Stag Brewery

Masterplan and Detailed Design and Access Statement Addendum

ORIGINAL PROPOSAL: GROUND FLOOR MASTERPLAN PROPOSAL FOR DEVELOPMENT AREA 1

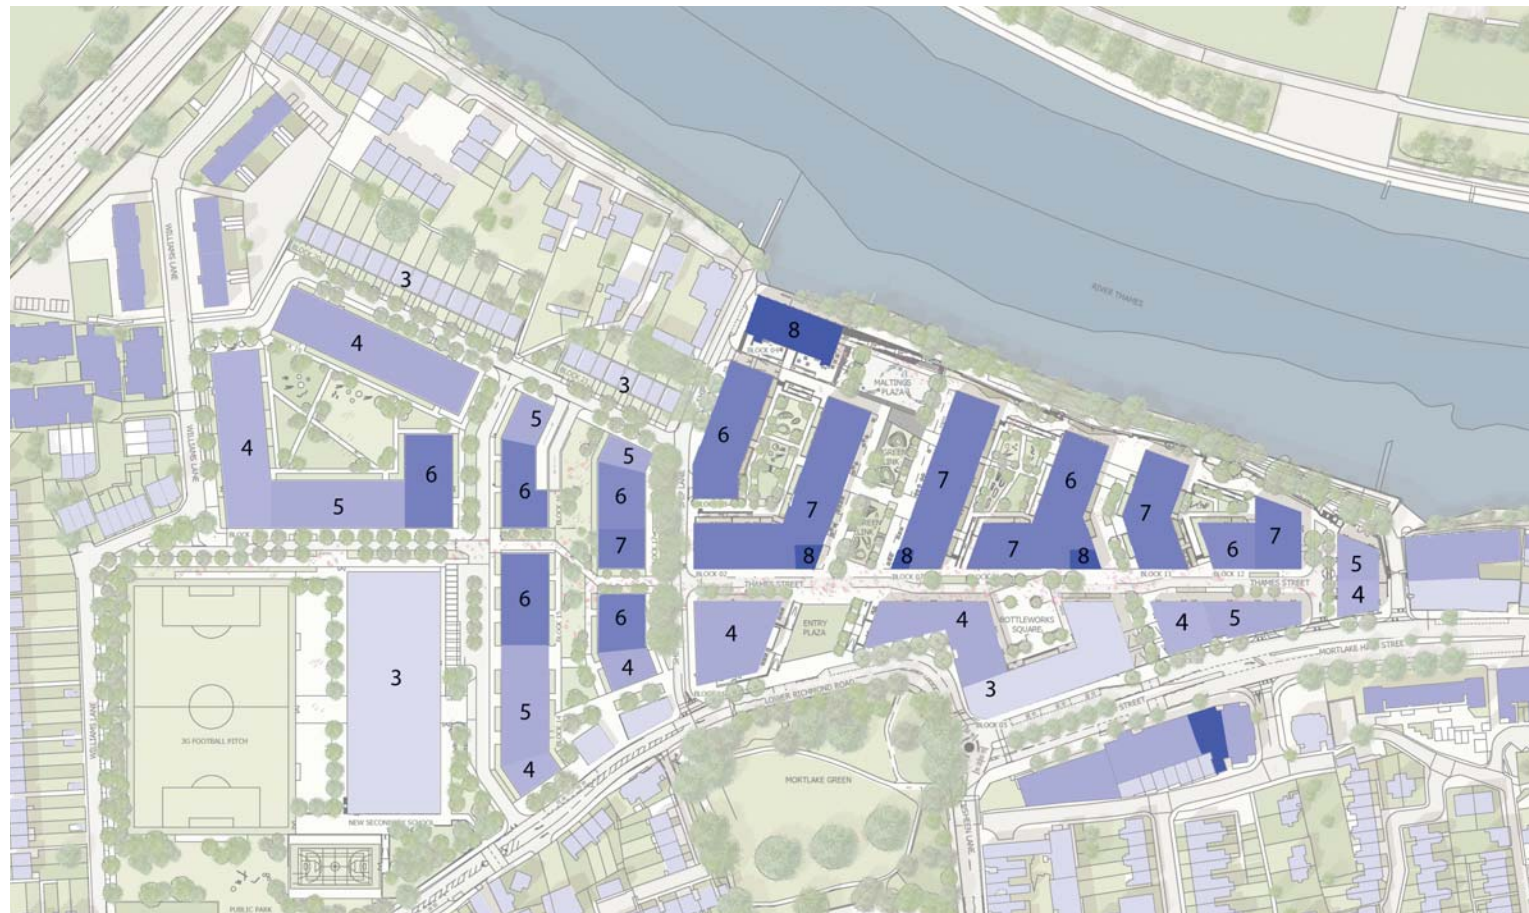
Key features of the original scheme are retained in the revised scheme and the perimeter of building footprints have generally remained the same as previously proposed.

Where slight changes are proposed, they have been incorporated to counter balance impact of increased heights and mitigate negative impact in terms of daylight, sunlight, overshadowing and Rights of Light. The main changes are to Development Area 2 in the outline component of the application. Here, slight changes proposed to the footprints of Buildings 18 and 19 and the replacement of Building 20 with two Buildings with a slightly deeper floor plate to allow apartments to be introduced. The Design Code document has been revised to reflect this change.

Other very minor changes to footprints have occurred as a consequence of aesthetic refinements to the mansion typology that is applied to Buildings 2, 3, 7, 8, 11 and 12 within Development Area 1. Block 22 (previously Block 21) has reduced from 8 units to 7.

ORIGINAL PROPOSAL: MASTERPLAN HEIGHTS

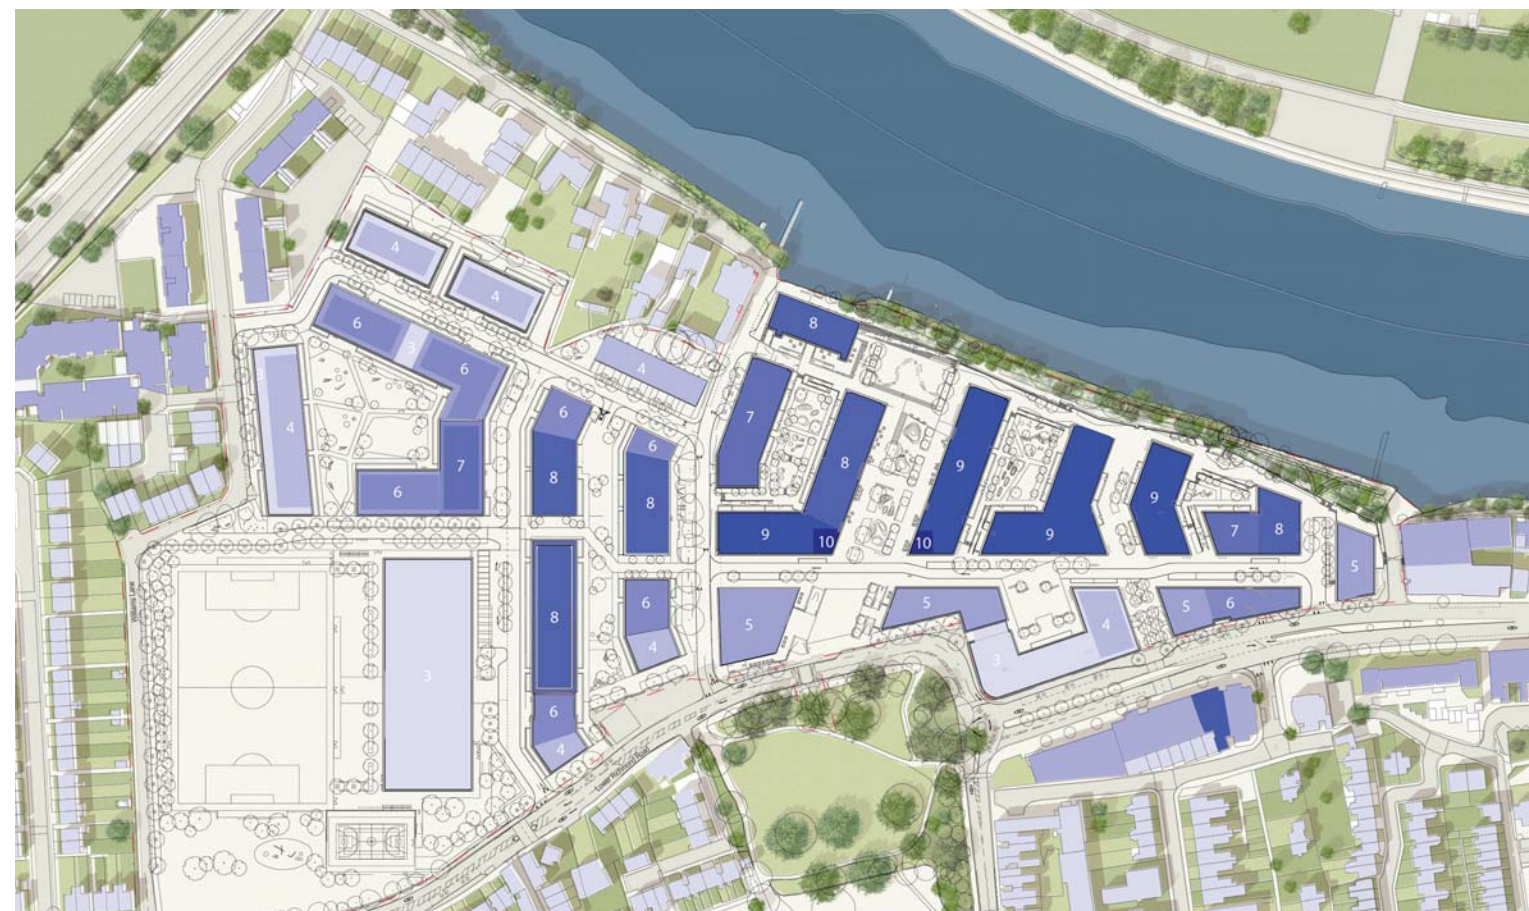
The heights of the revised buildings now range from three storeys up to ten storeys. The tallest elements of the masterplan are proposed at the centre of the site along the new Thames Street. Height increase has been more limited around The Maltings Building so it retains an element of prominence. Buildings 6 and 10 on Mortlake High Street have been slightly increased to more closely meet the maximum targets of the Planning Brief but without dominating the streetscape. Likewise, the massing to the perimeter of Development Area 2 has also been slightly increased to optimise the residential quantum, however the elements of Building 19 seen from the river have been limited in their height increase and have been divided at upper floors to reduce their massing.

ORIGINAL PROPOSAL: DEVELOPMENT AREA 1 TYPICAL FLOOR PLAN

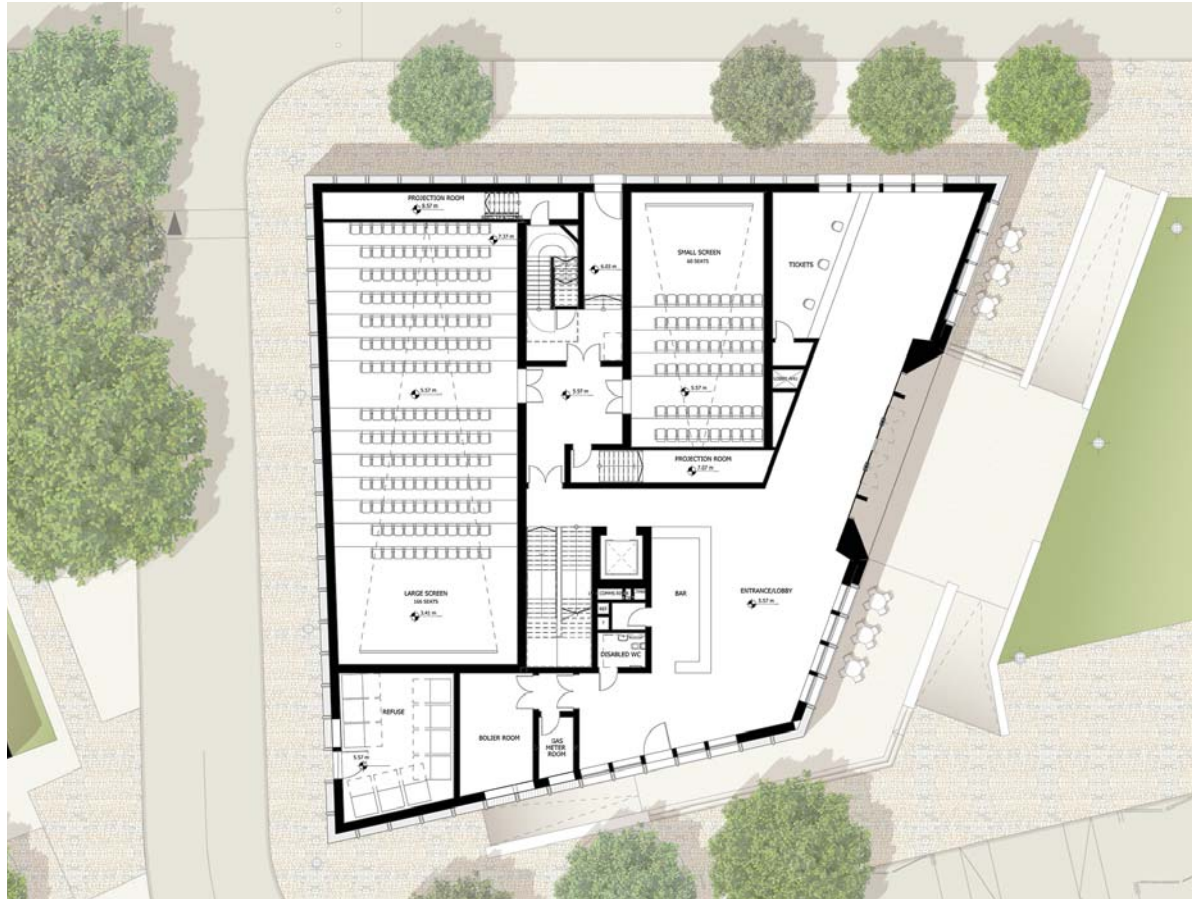
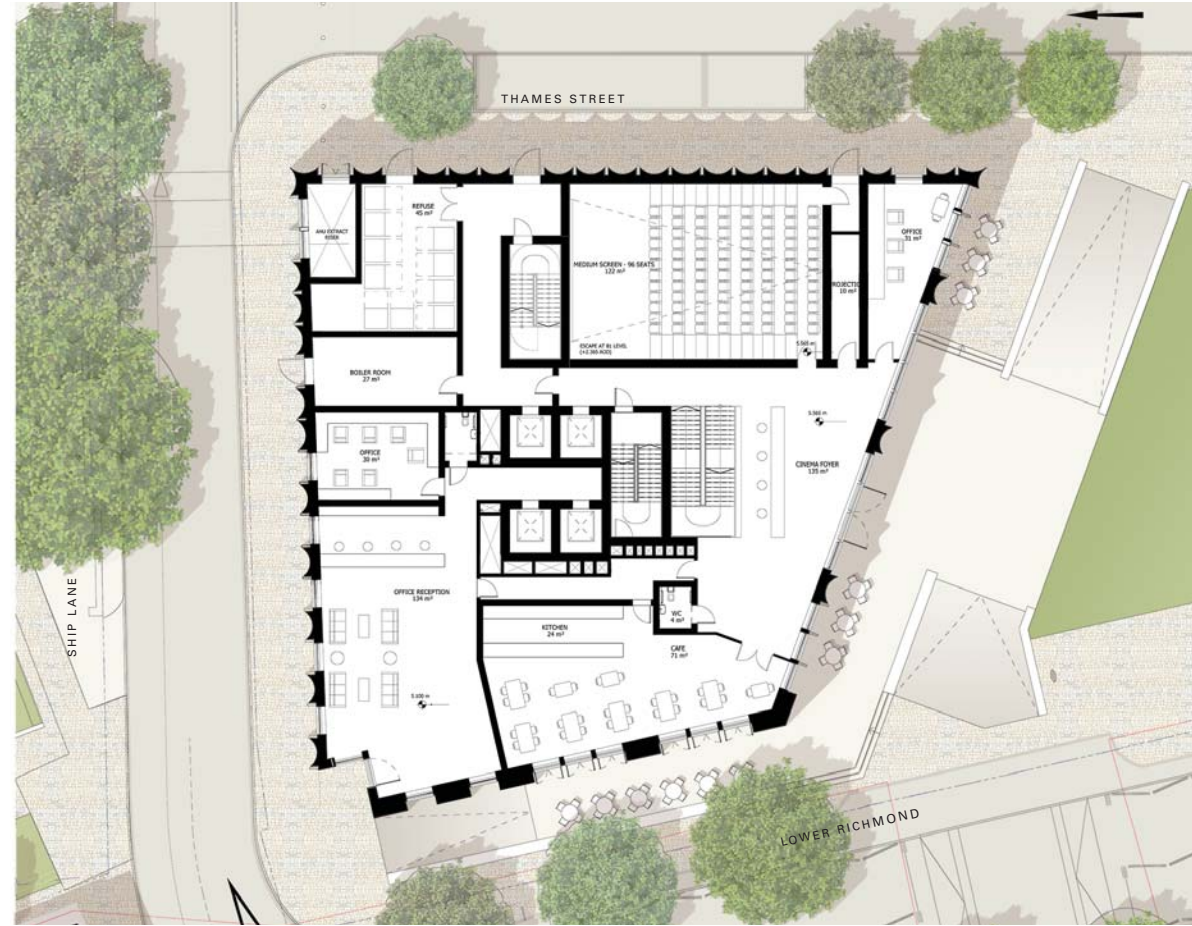
The general approach for the provision of residential units above ground floor level remains the same and most of the building entrances remain in the same or very similar locations allowing access and egress from and to both street and courtyard.

The main changes to mansion block buildings (2, 3, 7, 8, 11 and 12) are as follows:

- Building 2 has been redesigned to optimise the residential floor area and remove one of the three cores. This has resulted in a slightly different ground floor level entrance configuration. It has also resulted in one of the cores at the typical level serving 9 units and the other serving 8 units (as opposed to 5, 5 and 6 units per core). The benefit of this layout is an optimised GIA and number of habitable rooms per level (increase from 53 in addendum application to 54 per level in revised). The cumulative changes to this building (including height) have resulted in an uplift of 80 habitable rooms (from 321 to 401) and as a consequence have significantly increased the scheme’s ability to deliver a higher percentage of affordable housing by habitable room count.

- Due to an increase in number of storeys, Building 6 has been redesigned to contain one single core that contains two lifts. This has resulted in the reconfiguration of the ground floor layout to provide a single point of residential entrance with associated refuse storage. The mix of layouts per level has also been adjusted to meet the requirements of the intermediate tenure that the building now constraints.

ORIGINAL PROPOSAL : BUILDING 1 (CINEMA) GROUND FLOOR PLAN

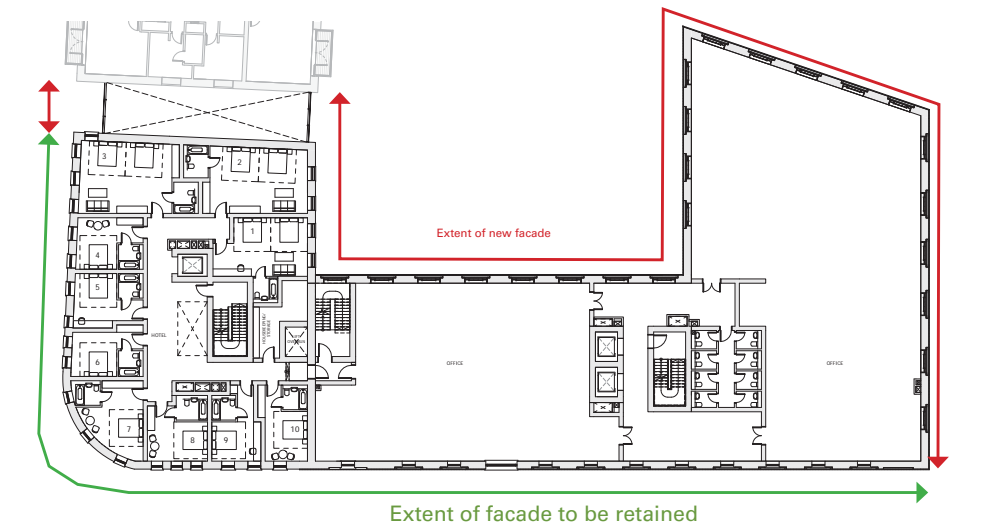
The standalone cinema building has remained the same in terms of footprint, but has been re-designed to serve as a mixed use building containing both cinema and office space.

The cinema accommodation has been condensed into two storeys of accommodation, the lower of which will sit at a lower ground floor level. The office accommodation will sit above the cinema space and be accessible via a ground floor level reception area at the junction of Lower Richmond Road and Ship Lane. Increased active frontage in the form of a small cafe (serving both cinema and office facilities as well as the general public) will be provided at ground floor level facing Lower Richmond Road. The cinema entrance will remain facing the entrance to the Green Link.

ORIGINAL PROPOSAL: BUILDING 5 FIRST FLOOR PLAN

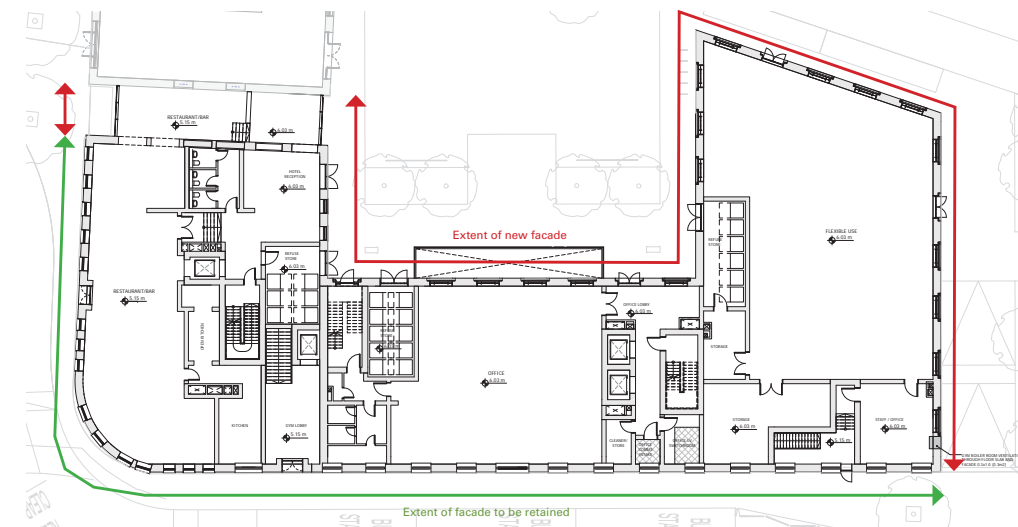
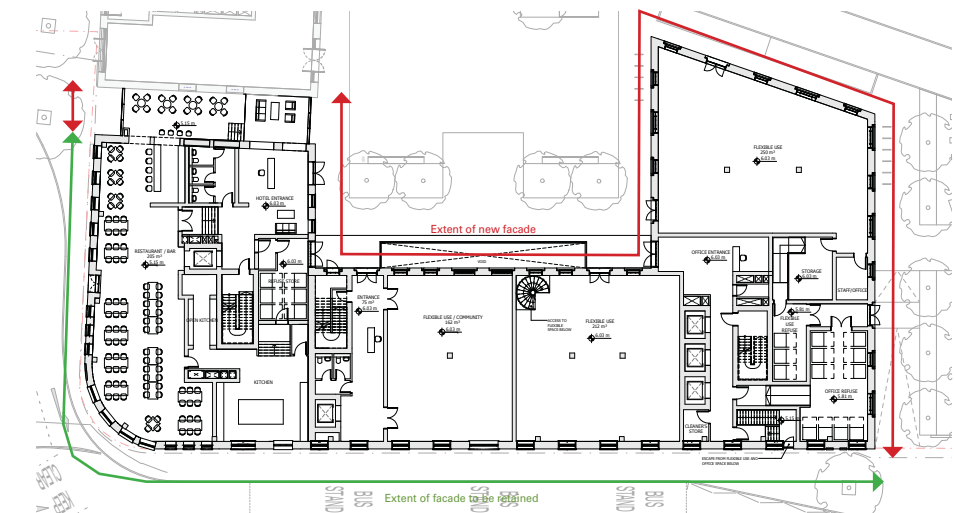
Building 5 has been revised slightly to remove the Gym use and increase the flexible use at ground and lower ground levels. The proposed footprint and extent of facade retention remains the same as previously proposed with only minor changes to the elevations.
